ADDENDUM No. 1 – Clarification and update to Bill of Quantities

Re: Tender for Construction of Reinforced Masonry Retaining Wall in Barzeys – Section 1 - 3

Site Plan

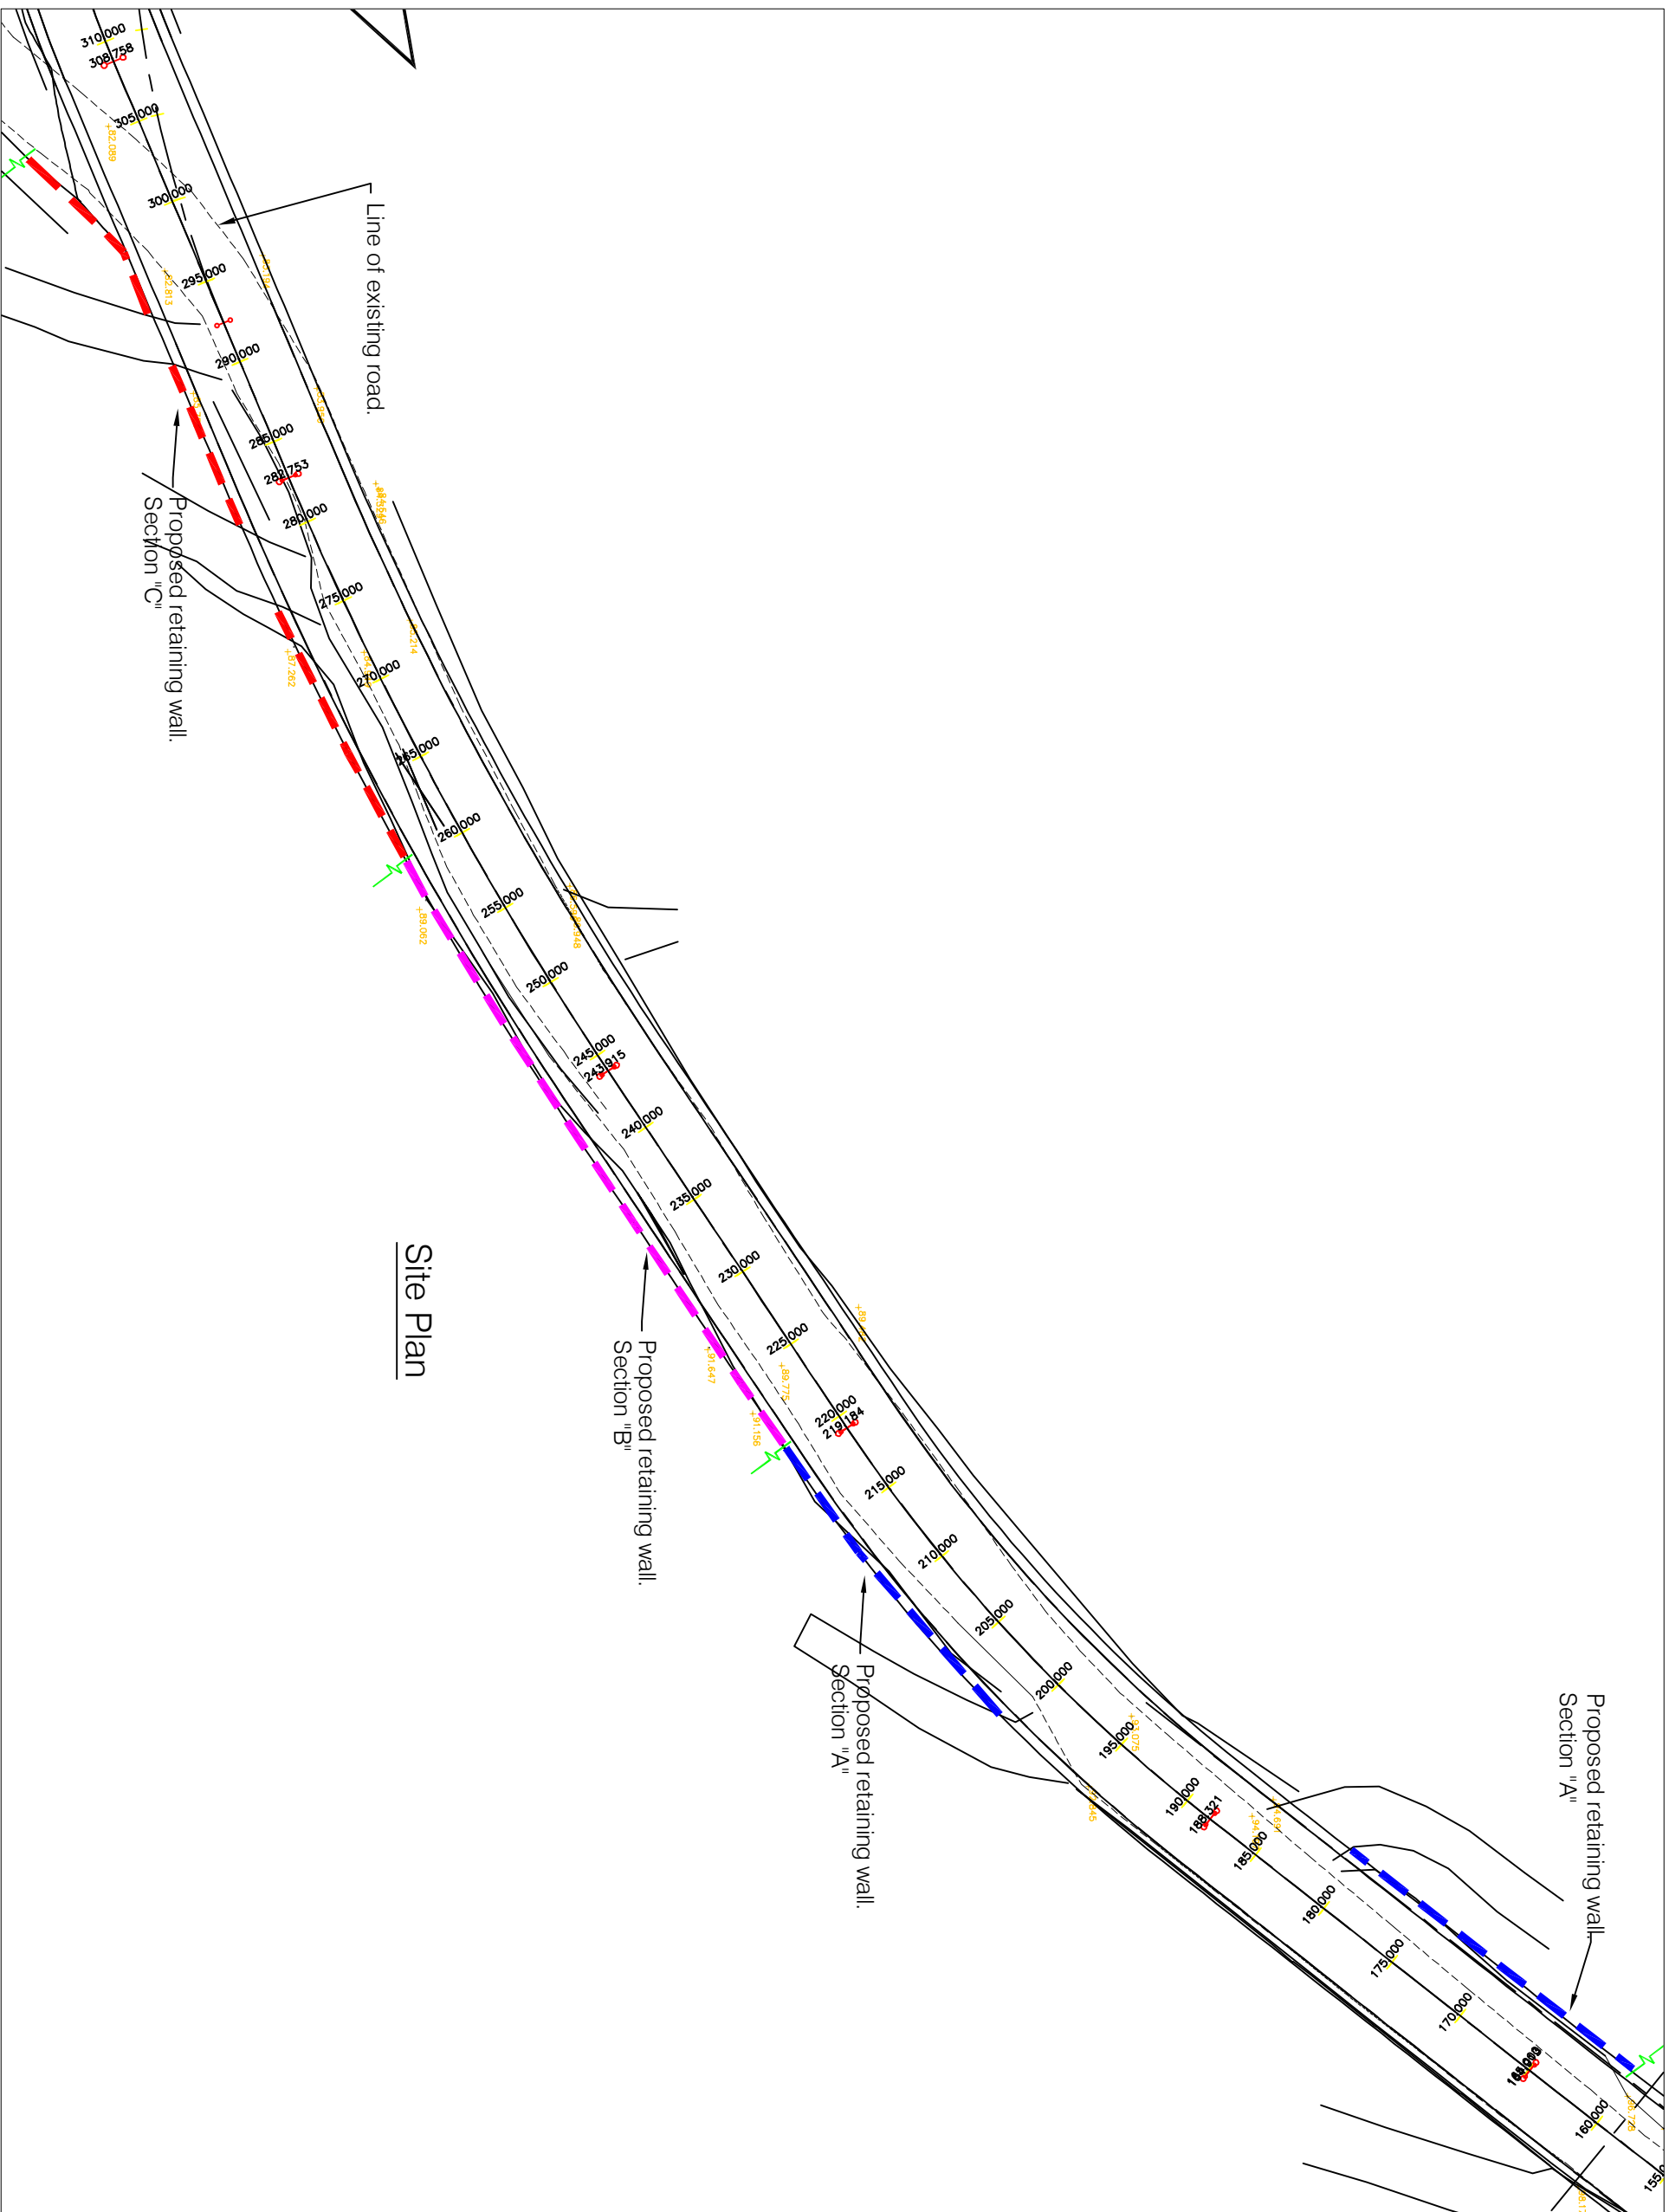
Please note below the addendum to the Bill of Quantities for the Tender for the Construction of Reinforced Masonry Retaining Wall in Barzey's River Section 1-3 under the Infrastructure Priority Project, issued on November 9th 2017. Similarly, the site plan for the area is attached. Section 1-3 is represented as Section A-B
